Report of the Chief Planning Officer

NORTH AND EAST PLANS PANEL

Date: 29 October 2015

Subject: 15/02915/FU – Single storey side and rear extension including raised decking area with steps and balustrading at 19 Chelwood Avenue, Moor Allerton, Leeds LS8 2BA.

Rev	Amendment	Date	By	Chkd
A	Roof extension amended to suit planning panel comments	27/8/15		
Status: Construction				
Drawing: Proposed Site Plan & Elevations				
Project: Extension to 19 Chelwood Avenue				
Scale:	Drawn By:	Checked By:	First Issued:	Dwg No. BR01
				Rev A

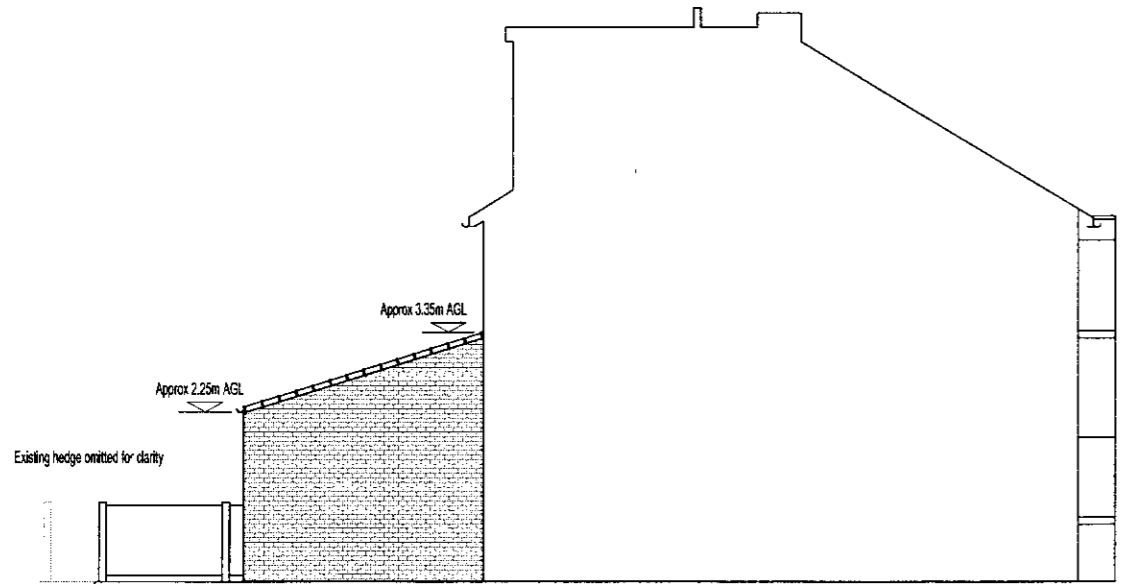
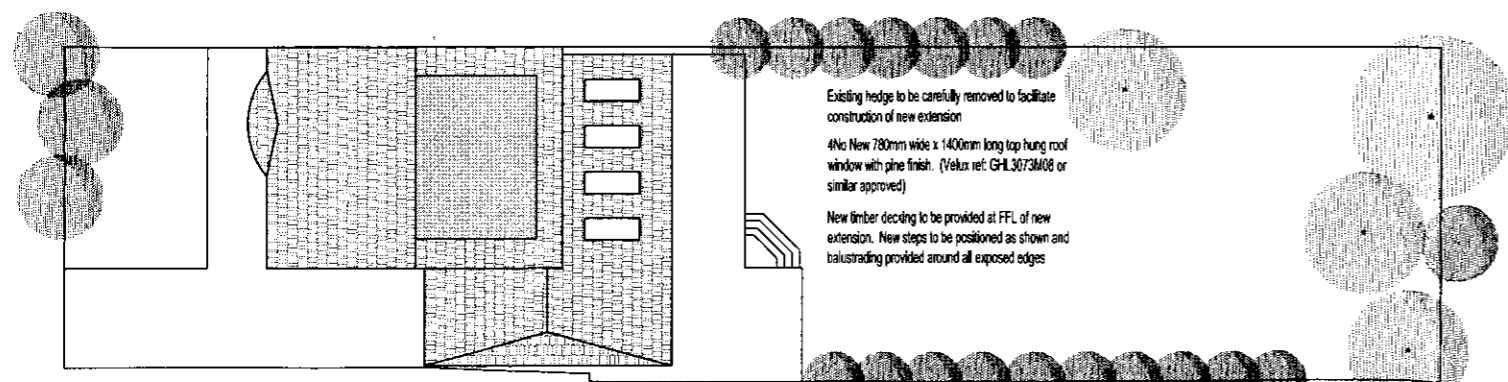
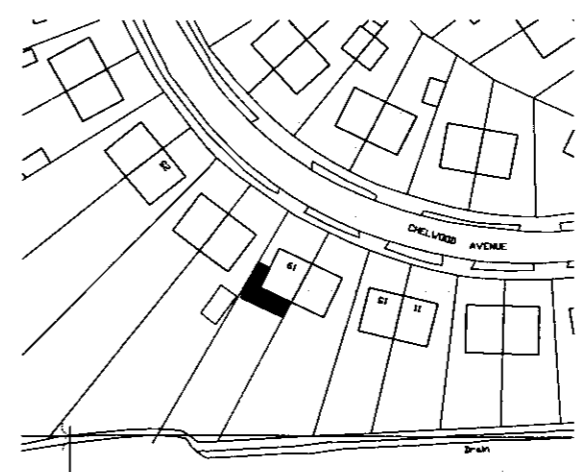
- We would like the roof to slope down gently towards us. The length of the roof ridge is detailed as 925cm, perhaps shortening the length of this would create a more gentle slope.
- Further clarity is needed regarding other measurements. On the original plans the maximum width of the drive, where the garage door is to be situated, is recorded as 2700cm. Accurate on site measurements record 2460cm at this point. This measurement was verified by a Planning Officer.
- Detailed plans are needed specifying all measurements, especially at the front to ensure that the guttering does not over-hang our boundary wall at the narrowest point.

- We would like the roof to slope down gently towards us. The length of the roof ridge is detailed as 925cm, perhaps shortening the length of this would create a more gentle slope.
- Further clarity is needed regarding other measurements. On the original plans the maximum width of the drive, where the garage door is to be situated, is recorded as 2700cm. Accurate on site measurements record 2460cm at this point. This measurement was verified by a Planning Officer.
- Detailed plans are needed specifying all measurements, especially at the front to ensure that the guttering does not over-hang our boundary wall at the narrowest point.

As stated above Officers are of the view that the applicant has met with the aims of Members requirements to hip the roof; he has also annotated the plans to show the Measurements as measured on site.
